UI BULLETIN # 93

SUBJECT: **External Radio Antenna Mounting Location Recommendation**

MODELS AFFECTED:
Hybrid Tahoe/Yukon Municipal Vehicles

DATE: **02/28/2011**

2011 and Beyond Tahoe Hybrid Municipal Truck

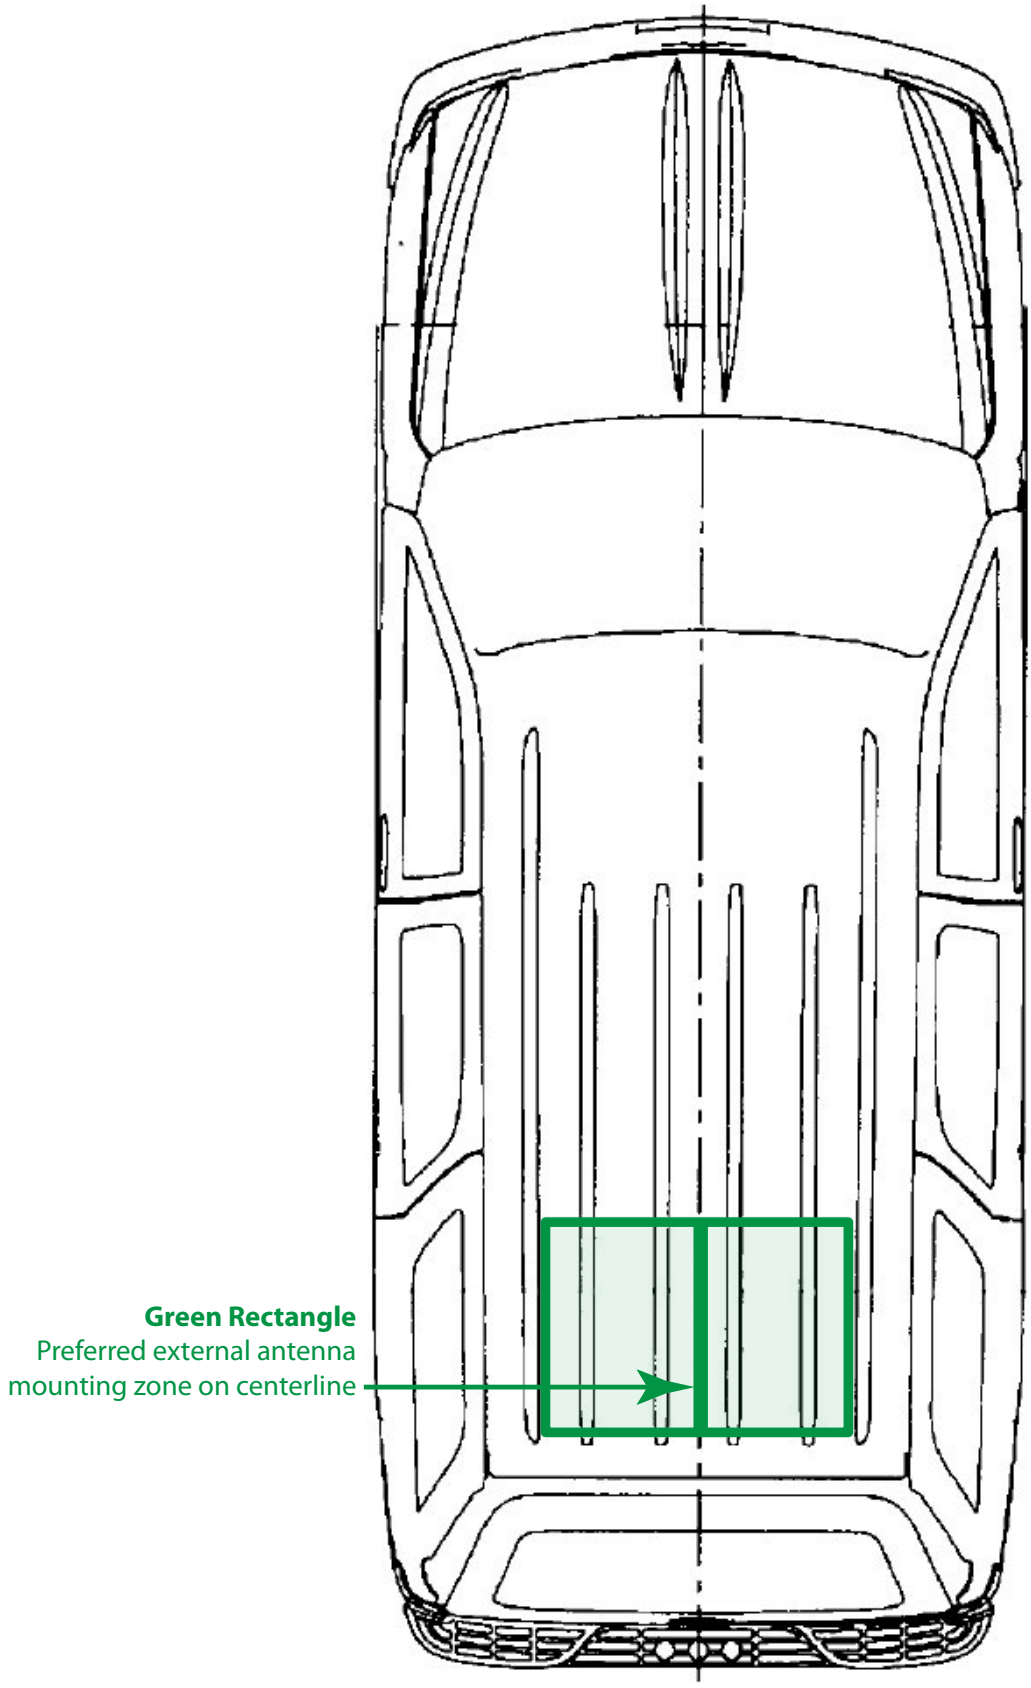
CONDITION/CONCERN:
The 2011 Hybrid Tahoe / Yukon Municipal Vehicle content may experience radio interference when using an external antenna mounted toward the front of the vehicle on the horizontal roof sheetmetal surface and poses less radio interference as the external antenna is located toward the rear of the vehicle.

It is entirely possible that a government fleet customer could not experience any issues even with a front mounted external antenna location, but the possibility of any interference diminishes if the external radio antenna is located on the rearward area of the roof sheetmetal.

Green Rectangle
Preferred external antenna mounting zone on centerline
